MACK TRUCKS, INC.
2100 MACK BOULEVARD
P.O. BOX M
ALLENTOWN, PA 18105-5000

SUBJECT: Vehicle Safety Recall - SC0326
Steering Shaft Locknut

SC326

Subject: Steering Shaft Pinch Bolt and Locknut Replacement — GU7 and CHU Models

Figure 1 — Steering Shaft Pinch Bolt and Locknut

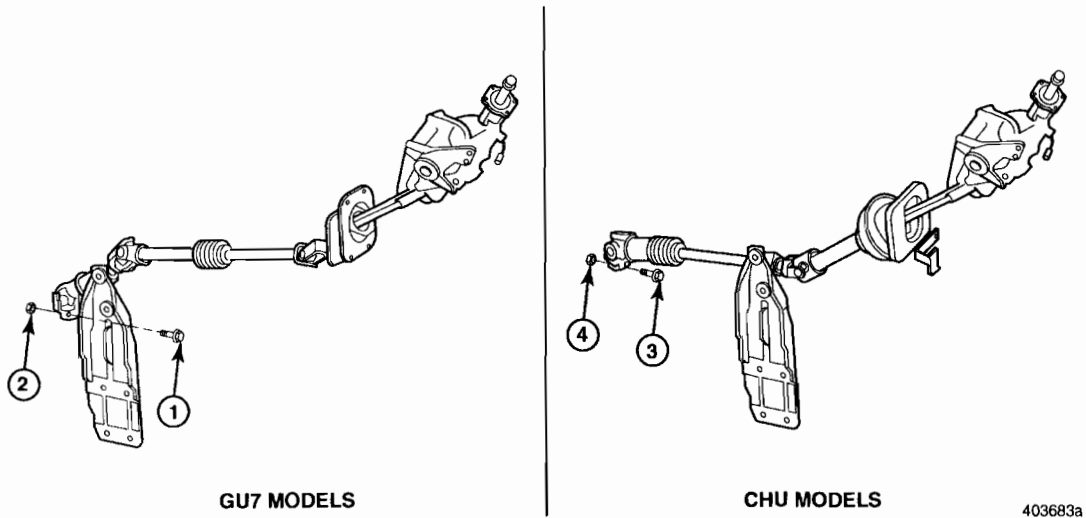
On certain GU7 and CHU model chassis manufactured between November 14, 2006 and May 22, 2007, it has been determined that the locking feature was omitted during the manufacturing process of the locknut used with the pinch bolt which retains the steering shaft to the steering gear input shaft. Should this nut come loose, the possibility exists for the steering shaft to separate. Approximately 1,072 GU7 and CHU models are affected by this campaign. A list of affected vehicles has been sent to all applicable dealers.

On GU models, metric hardware (10 mm x 1.5) was used for the steering shaft pinch bolt and locknut. This campaign is replacing the metric hardware on GU models with 7/16-20 UNF hardware.

1. Secure the chassis for service, apply the parking brakes and block the wheels to prevent the vehicle from moving.
2. Open the hood.
3. Remove the existing pinch bolt and locknut from the universal joint at the steering shaft-to-steering gear connection (refer to figure 1).

4. Install a new pinch bolt and locknut. Refer to the chart below for the pinch bolt and locknut part numbers.

Key	Qty.	Part No.	Description
1	1	3AX1876	Bolt, 7/16-20 UNF - 2" long — GU7 models
2	1	21AX789	Locknut, 7/16-20 UNF — GU7 models
3	1	43RU42M	Bolt, M10 x 1.5 - 45 mm long — CHU models
4	1	171AM16	Locknut, M10 x 1.5 — CHU models

5. Tighten the pinch bolt locknut proper specifications as follows:
 - 7/16" pinch bolt — 95 N•m (70 lb-ft)
 - M10 pinch bolt — 60 N•m (44 lb-ft)
6. Mark the new nut with a yellow paint stick to signify that the pinch bolt and locknut have been replaced.
7. Return the vehicle to service.
